ADDENDUM NO. 2

**CITY OF HIALEAH
72 UNIT ELDERLY HOUSING
275 PALM AVE.
HIALEAH, FLORIDA**

The original Contract Documents, for the Project entitled **CITY OF HIALEAH – 72 Unit Elderly Housing, RAILINGS AND MISCELLANEOUS METALS BID NO. 2012/13-3230-00-023** is hereby amended as noted in this **Addendum No. 2**.

**PATTERN OF PERFORATIONS ON SCREEN
ON BALCONIES BLOW UP - RFI**

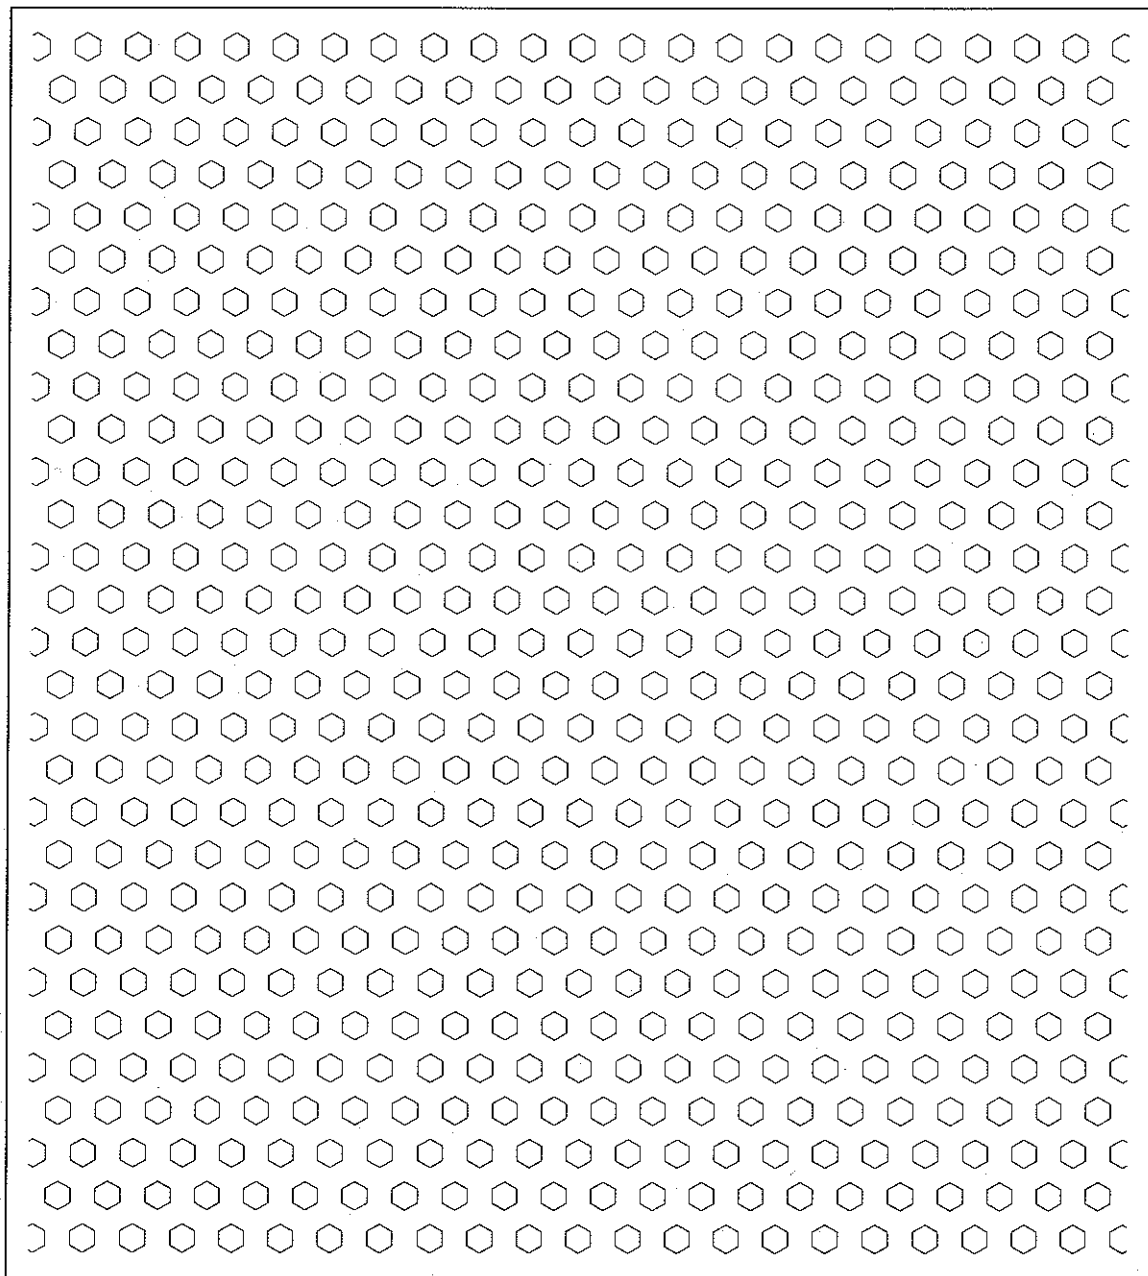
- 1) The size of the perforations on the decorative screens on the balconies.
See Architect's sketch attached, 'Pattern of Perforations on Screens' (Pages 1 & 2)
- 2) Please provide the type of finish on the decorative screens on the balconies.
Decorative Screens: Aluminum Silver powder coat
Railings: White
- 3) Please provide the location and quantity of the bollards (Detail 11, Page AS-002).
There are no indications on the plans that bollards are to be provided. Typically when a 6" high curb or sidewalk is provided, as in this case, bollards are not required. Sidewalk along the perimeter of the building is supposed to be 6" high.
- 4) Are the concrete columns on the perimeter fence being installed by the shell contractor or the Iron contractor?
(Detail 10, Page A-701)
Bidders are not to include the perimeter fence or concrete columns in their proposals.
